Davidson Creek/Clarkdale Meadows Traffic Calming Project

Open House and Online Survey Results

Figure 5: Proposed Options for Davidson Drive Trail Crossing

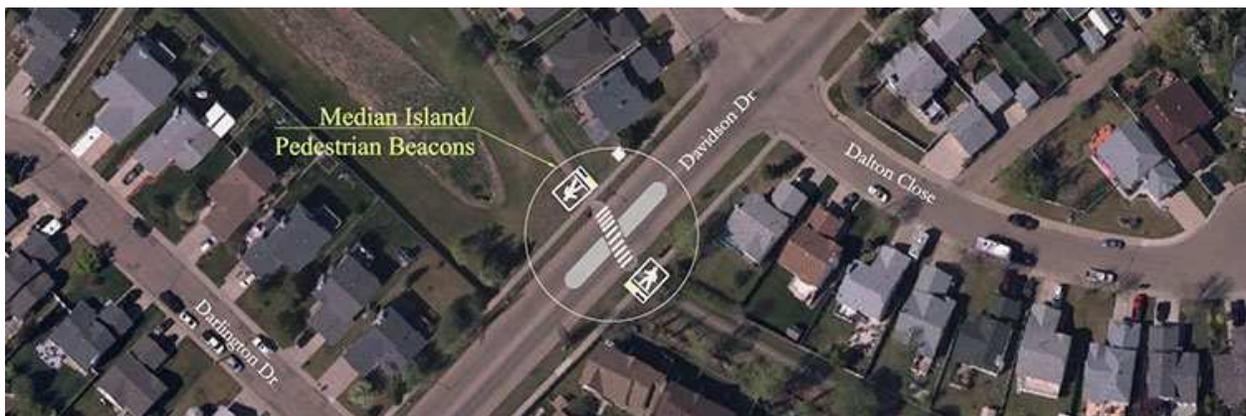
- High traffic location used by many children (7-11), going to playground, and also commuting to school. Better to have another layer of safety to protect pedestrians.

- My daughter and I were almost hit in this crosswalk, Something definitely needs to be done here.
- Beacons would make pedestrian safety better since people normally park in that area and drivers may not see pedestrians.

- I do not feel the requirement for a median is appropriate.
- I would be interested in knowing what the recommendation is and why - just seeing these two options without other data isn't really helpful

- I am not sure why you need a median island if you just put up pedestrian beacons, that would save money and also solve the problem with pedestrians crossing there.

- Prefer with beacons
- The Beacons might not be totally necessary, but if that school is going to be just down the street from there? Maybe there are?
- is it possible to only put in flashing lights? Why is the median necessary?

- Don't plant bushes in the median
- Would rather see a good street light with raised sidewalk than expensive beacon system
- I think that pedestrian beacons would be more visible. I do not agree on the islands.

- People pay more attention to pedestrian beacon
- Median with narrow road is hazardous. Just have beacons

Figure 9: Proposed Options for Davenport Drive at the Playground

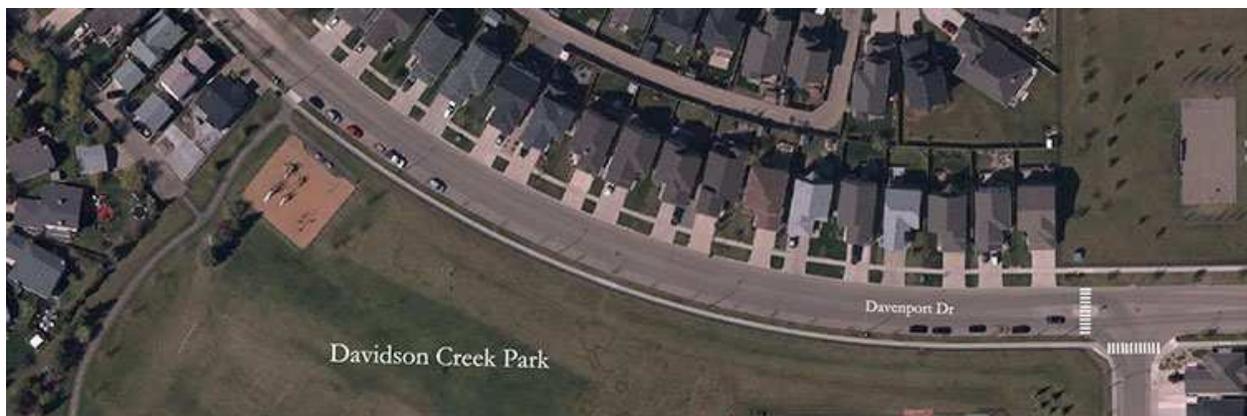
- Not sure if other, better (perhaps more expensive) alternative exists. Do other alternatives exist?
- Remove existing median. It is already a problem. Or don't allow parking within 10m of it.

- Calming circles at both ends would be ideal (like by Lakeland Ridge school)
- Speed humps will just cause congestion and noise.
- again, what is the recommendation in this situation?

- How do speed humps affect the clearing of snow? How often do they need to be replaced? Not sure how permanent of a solution this is and how cost effective if they need to be replaced or if they interfere with snow removal. When the school goes in I would like to see pedestrian beacons in 2 locations along Davenport Dr. One at Dorian Way and Davenport Dr. and one at the other end of the park where the school is going to be located.

- There must be something else. Speed humps are not a great option
- If speed humps are used build them on a diagonal
- I do not believe speed bumps are a good option.

Figure 13: Proposed Options for Darlington Drive

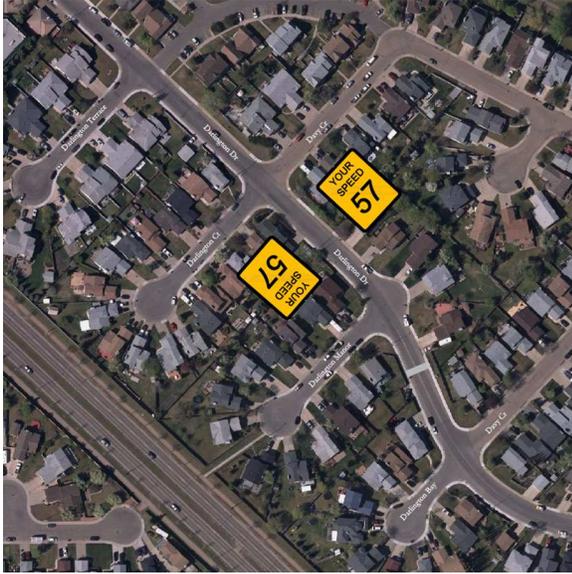
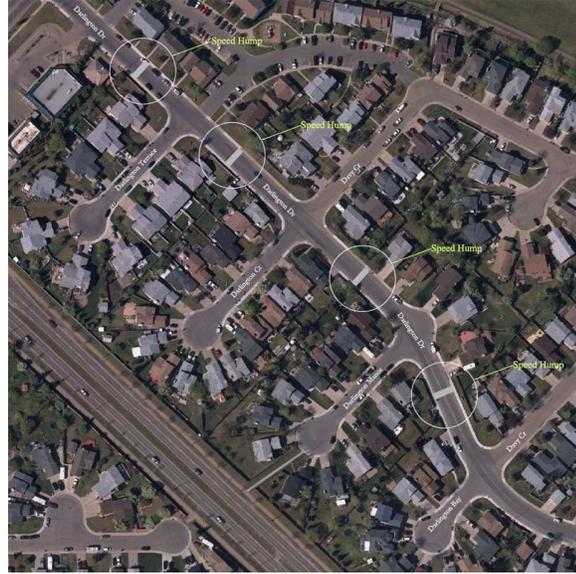
- If they are cheap and solar powered
- Don't see the speed display boards having any effect, especially if nothing is done about the people speeding.
- We do not see this area as being as high of a concern as Davenport drive. So if it comes down to budget, then permanent speed signs would be preferred and budget be used where it is more needed.

- Speed humps will just cause more noise and possible collisions due to people rapidly slowing and speeding up. Also is a concern for myself who drives a low car that has troubles going over speed humps.

- I am not in favour of speed humps. It is a permanent "solution" to a temporary issue.
- Darlington Drive seems to be lumped together but there are 2 distinct sections which is confusing

- Speed humps hard on suspension, increased noise, poor for transit and snow plows.
- How do speed humps affect the clearing of snow? How often do they need to be replaced? Not sure how permanent of a solution this is and how cost effective if they need to be replaced or if they interfere with snow removal.

- Display boards are the best method for reminding drivers to slow down
- If you put up the 'your speed' signs make sure there is a speed limit sign with it!

Figure 17: Proposed Option for Davenport Drive east of playground zone to Clarkdale Drive

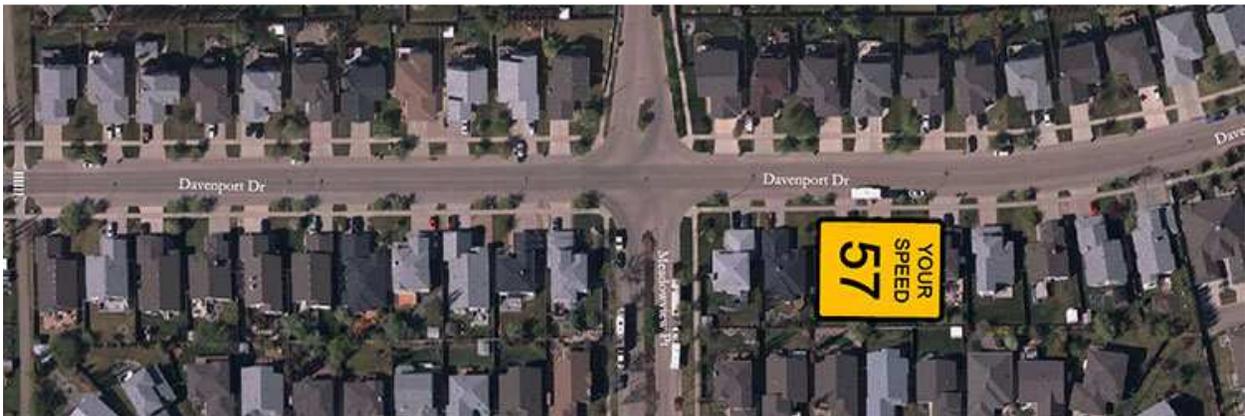
- If they are cheap and solar powered
- Same as before, don't think the speed display boards will make a difference.
- People will eventually ignore and get used to the speed signs. Speed bumps would seem to be more effective and be less of a cost.
- Speed humps are not a good option.
- How do speed humps affect the clearing of snow? How often do they need to be replaced? Not sure how permanent of a solution this is and how cost effective if they need to be replaced or if they interfere with snow removal.
- Not a true problem. In this case perceptions does NOT equal reality.
- Speed boards do not work for the individual that is travelling at a high rate of speed. Might work for the slower drivers, but these are less of a concern in my opinion
- People get too accustomed to going over the speed limit over time and don't care
- No permanent boards

Figure 25: Proposed Options for Clarkdale Drive at Orchid Crescent

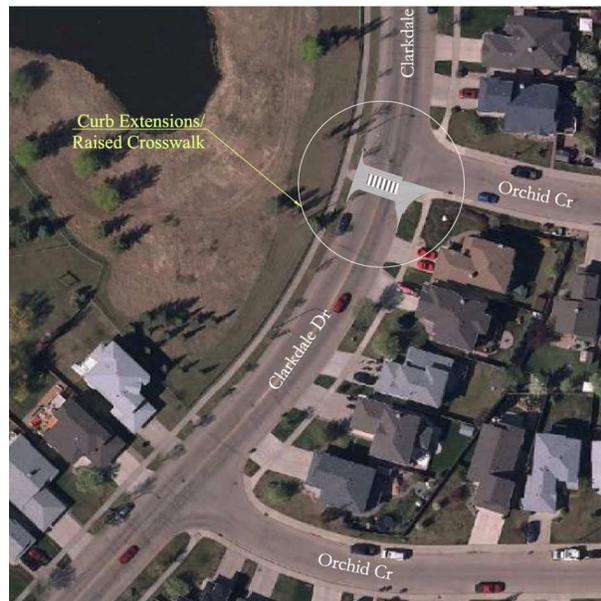
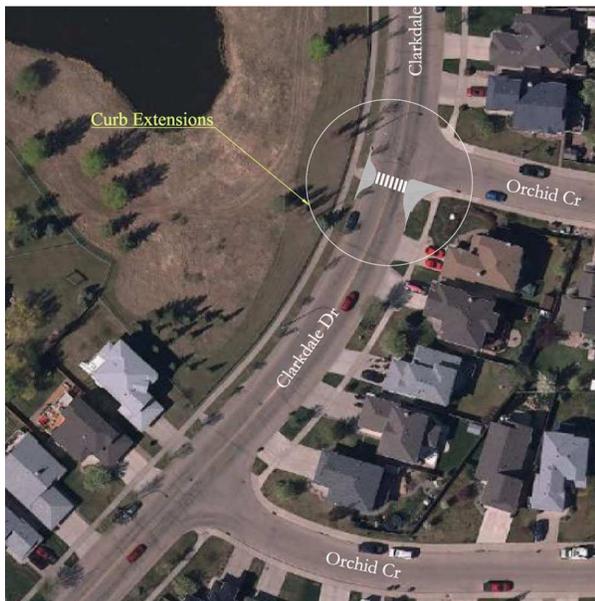
- Leaving near a curb extension, these are VERY EFFECTIVE. Strongly 4.
- The cost seems to outweigh the benefits. Could there just be a crosswalk and some lights instead? Or a speed bump?

- Not sure how a raised crosswalk would work. I have the same concerns with clearing snow and cost of replacing the raised sidewalk. How long would it take to wear down? How raised is it and how does that slow down traffic? Why not but pedestrian beacons at the crosswalk?

- Prefer raised crosswalk. Signs required warning of curb extensions
- This is just down the block from where we live and your proposals are ridiculous. This is not a local issue.

- Curb extensions only if they are clearly marked

Figure 29: Proposed Options for Meadowview Drive at Lilac Terrace

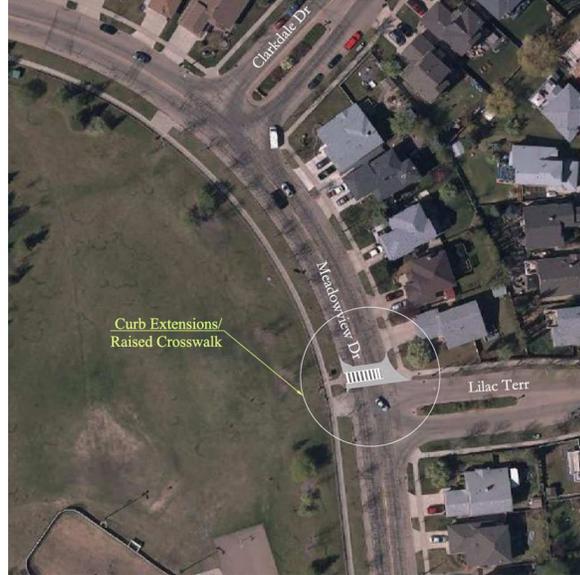
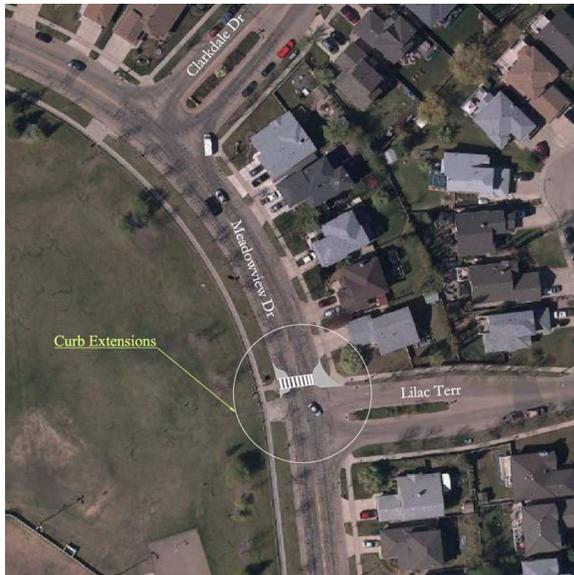
- Again not an issue
- It's a squeeze to turn with traffic approaching
- Not needed. Too expensive.
- I think the issue with traffic calming is an issue on Meadowview Drive. As a frequent walker in the greater neighbourhood, it is on Meadowview that I see excessive speeds.
- Why can't we put flashing pedestrian light here?
- Why can't we just have a crosswalk???
- Support Marked Crosswalk

- Snow storms obscure curb visibility
